Manufacturer Product Service Bulletin

Number CW03-01

Subject: Capewell Supplied Pins and Ripcords

Broken Ripcord Pin

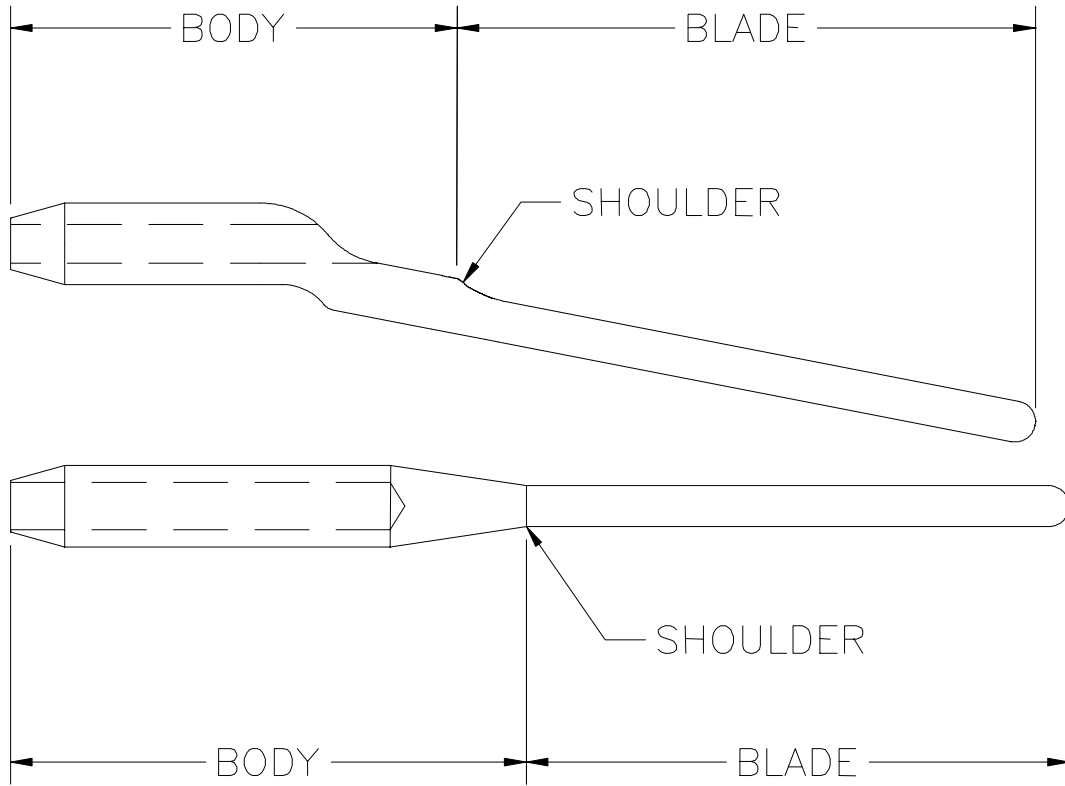
Capewell Components LLC has received (3) reports from (3) customers of (4) ripcord pins that broke. All (4) pins were reported to have broken under very low force. All (4) pins are reported to have broken on the blade section of the pin, approximately 1/8” (3 mm) from the shoulder of the pin. A broken pin is pictured below.

Affected Ripcord Pins are: MS70107 (angled), PS70107 (angled), 61C4304 (angled); 55A6480 (terminal)

WARNING: A DEFECTIVE PIN COULD CAUSE A PARACHUTE SYSTEM TO MALFUNCTION

FIGURE 1

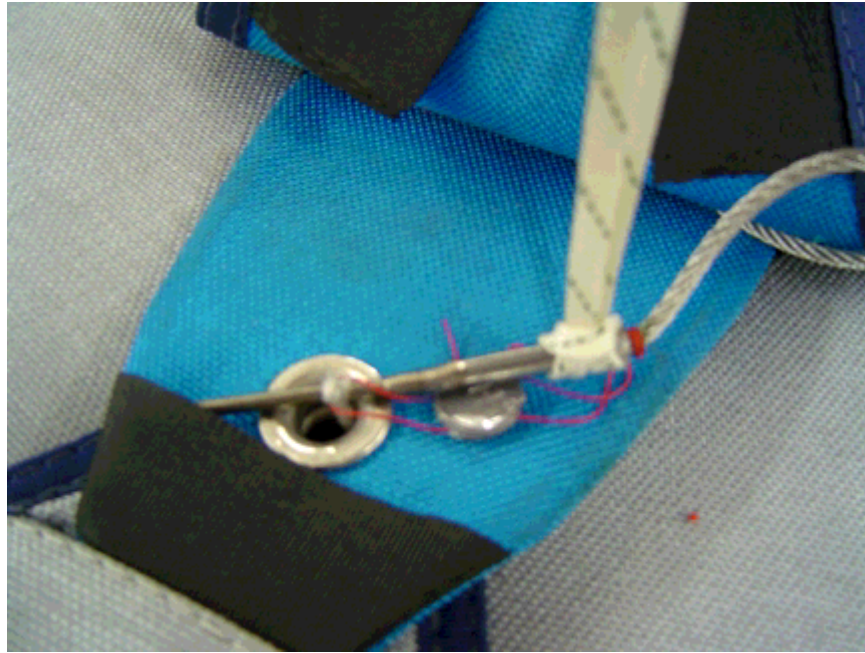
3. Take the suspension line and tie the two ends together with an overhand knot forming a loop.
4. Route the loop around the body of the pin to form a lark's head knot as close to the cable entrance end of the pin body as possible (Fig. 1).

5. Secure the other end of the loop to the spring scale.
6. Apply a load of 15 lbs. (6.8kg) straight up and 90 degrees to the axis of the pin for a period of 3 seconds and then release the load (Fig. 2). Inspect the pin for any deformation or bend. If the pin is straight, continue with step 7 below. If the pin is not straight, as visible without magnification, remove the pin/ripcord from service immediately.

FIGURE 3
All dimension in inches

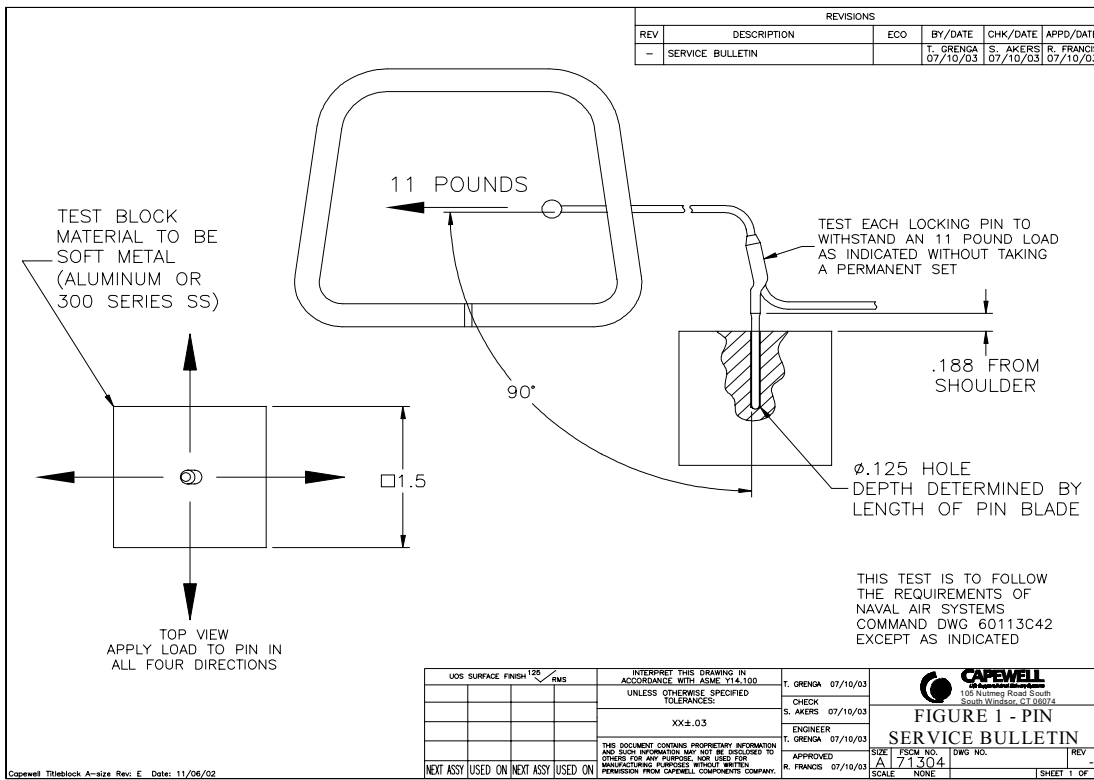
1. Place pin in test block per Figure 3 (below). NOTE: The pin block hole may be VERTICAL or HORIZONTAL
2. Apply 11 lb. force 90 degrees perpendicular to the pin blade.

3. Remove pin from block and inspect:
 - For straightness: Pins in excess of .005 (.12 mm) deformation along the blade of the pin should be removed from service.
